UNITED STATES  
ATOMIC ENERGY COMMISSION  
WASHINGTON, D.C. 20545

File (SEFOR, Docket No. 50-231)

PROPOSED CHANGE TO THE ADMINISTRATIVE SECTION OF THE TECHNICAL SPECIFICATIONS (PROPOSED CHANGE NO. 7)

Figure 1

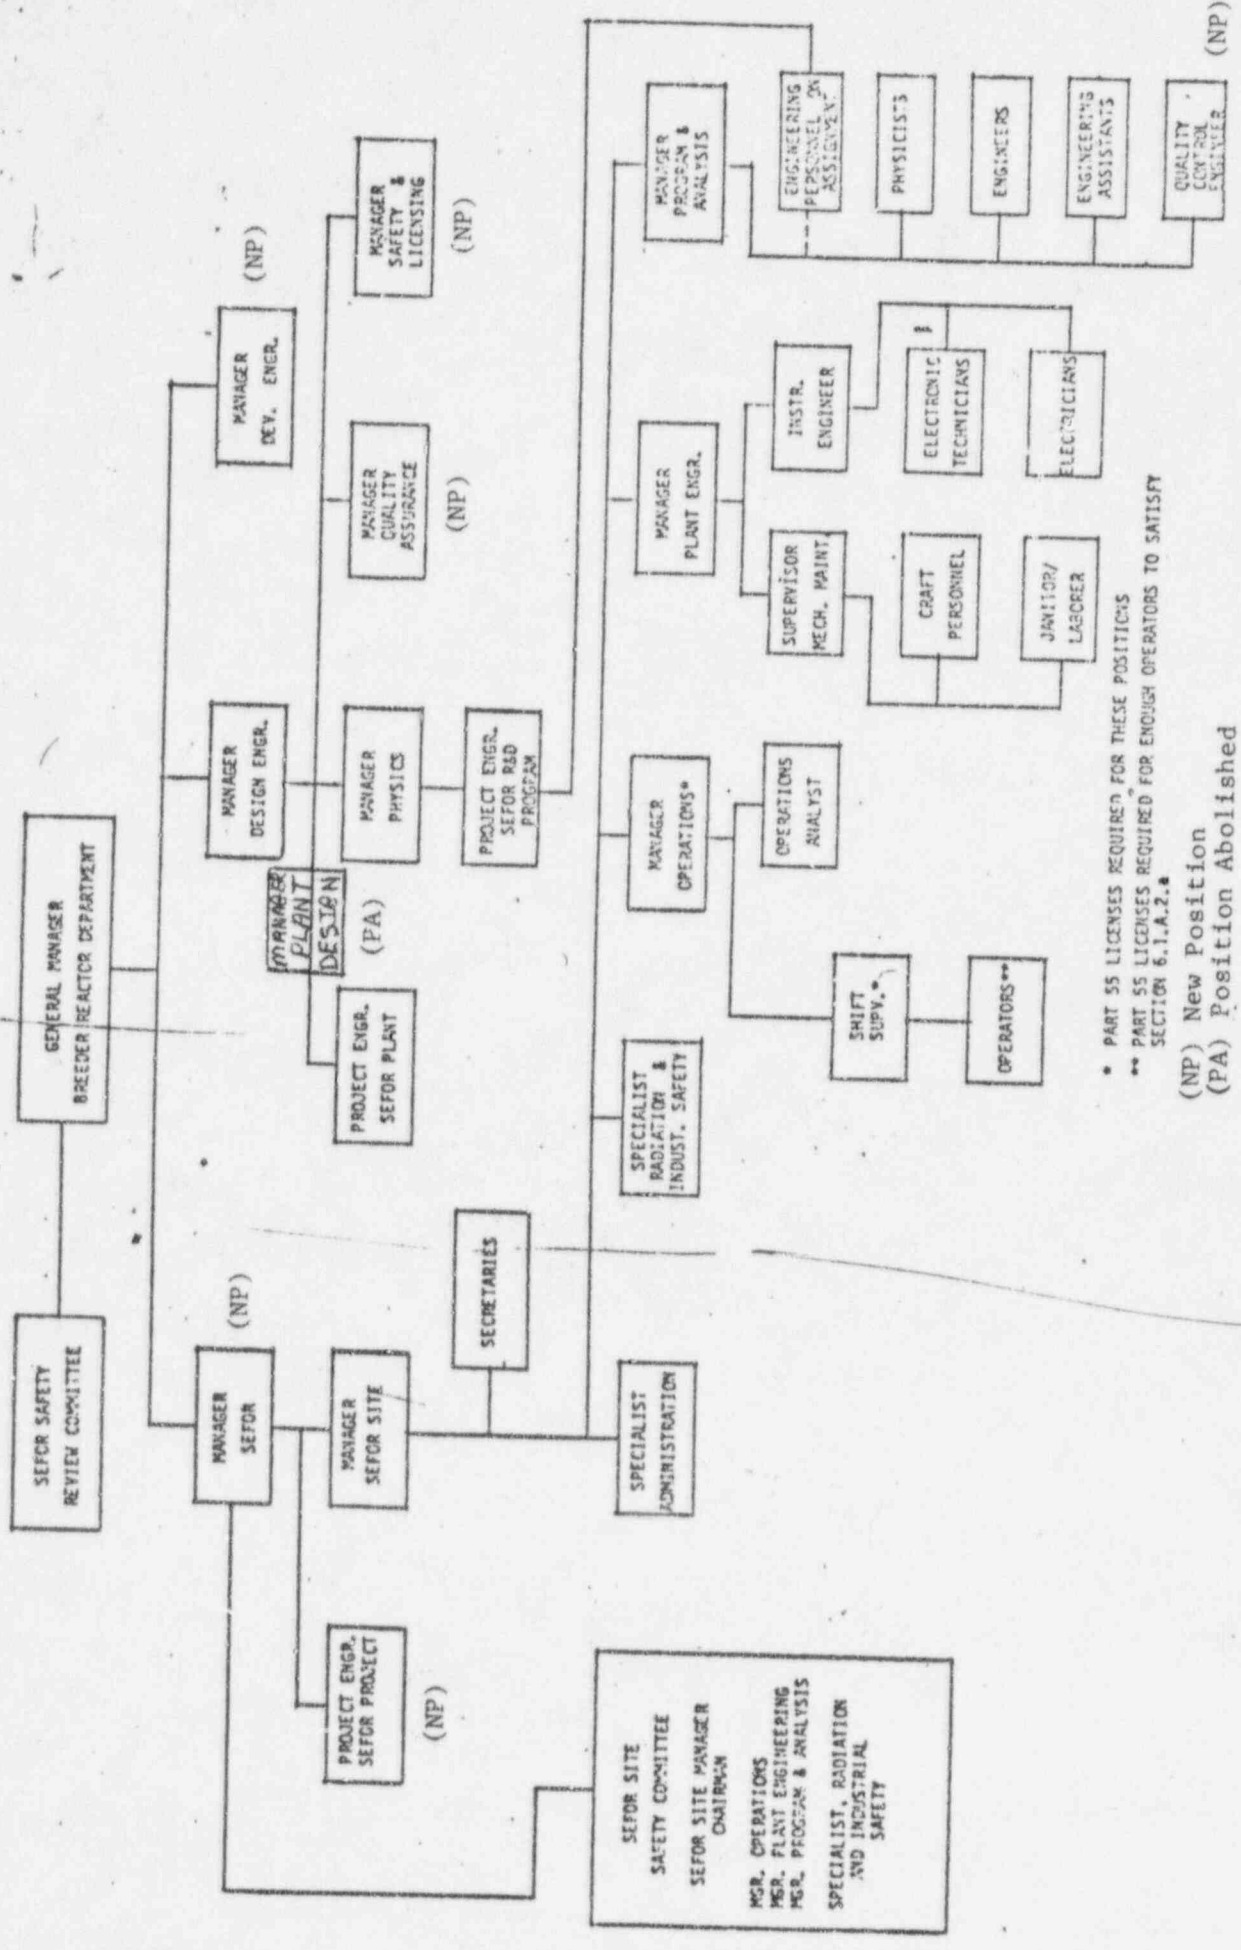
Figure 1 shows the present organization required by the Technical Specifications. As is evident, there is no indication of line responsibility for the SEFOR Site Safety Committee (SSSC).

Figure 2

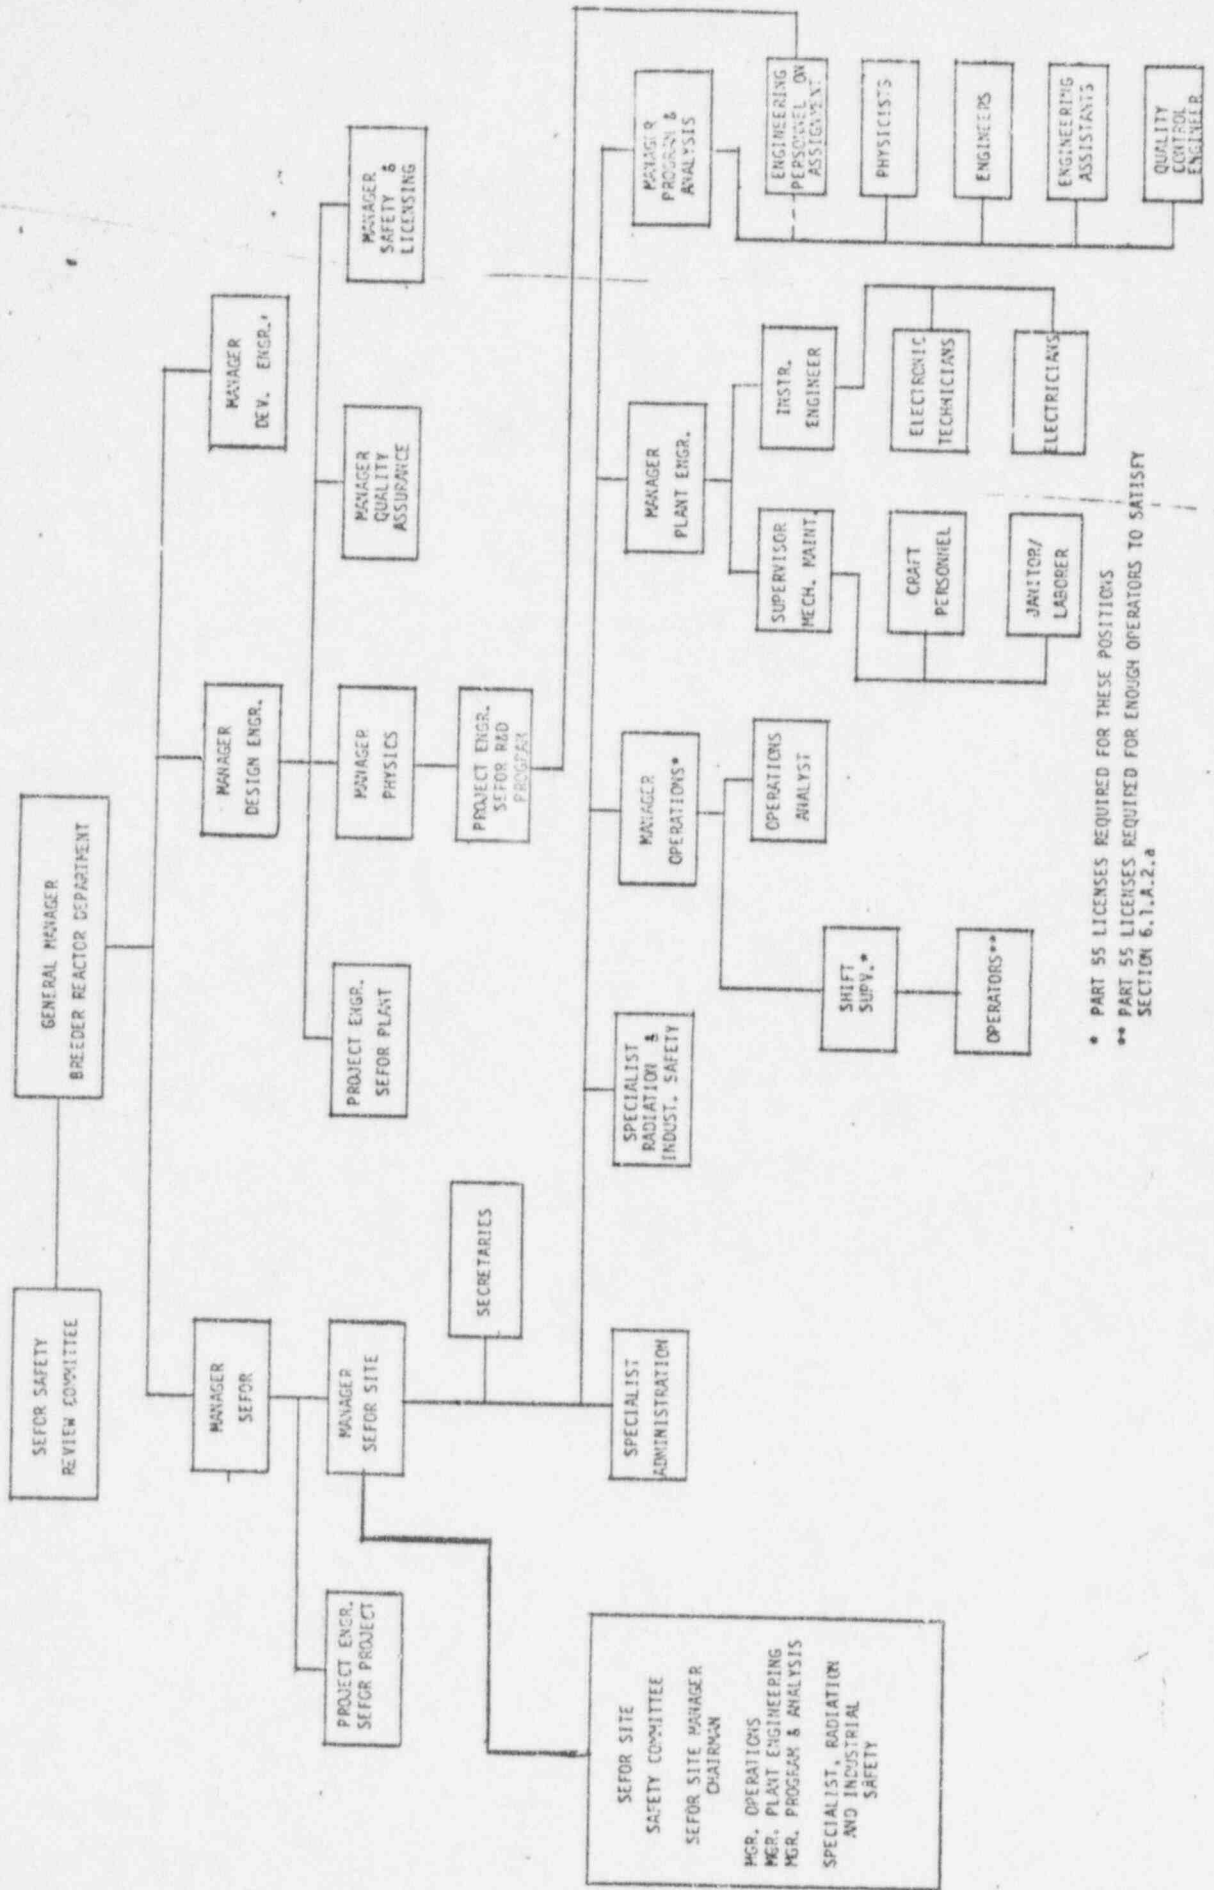
Figure 2 shows the proposed organization chart. This chart indicates that the SSSC reports to the Manager, SEFOR (new position). It also shows new positions (NP) that have been added, and a position that has been abolished (PA).

In conjunction with the designation of the new position (Manager, SEFOR), General Electric proposed qualifications for incorporation in the Technical Specifications. The Manager, SEFOR will be in the off-site management structure with offices at Sunnyvale, California. We see no necessity for off-site position qualifications in the Technical Specifications (Reference ANSI, N18.1-1971). We also believe that the SSSC should report to the Manager, SEFOR Site (Figure 3) instead of the Manager, SEFOR (Figure 2). General Electric agreed (Telecon 10/20/71, C. Russell, SEFOR and A. Brauner, DRL) that the qualifications for the Manager, SEFOR should not be in the Technical Specifications and that the SSSC should report to the Manager, SEFOR Site and suggested we modify the organization chart accordingly.
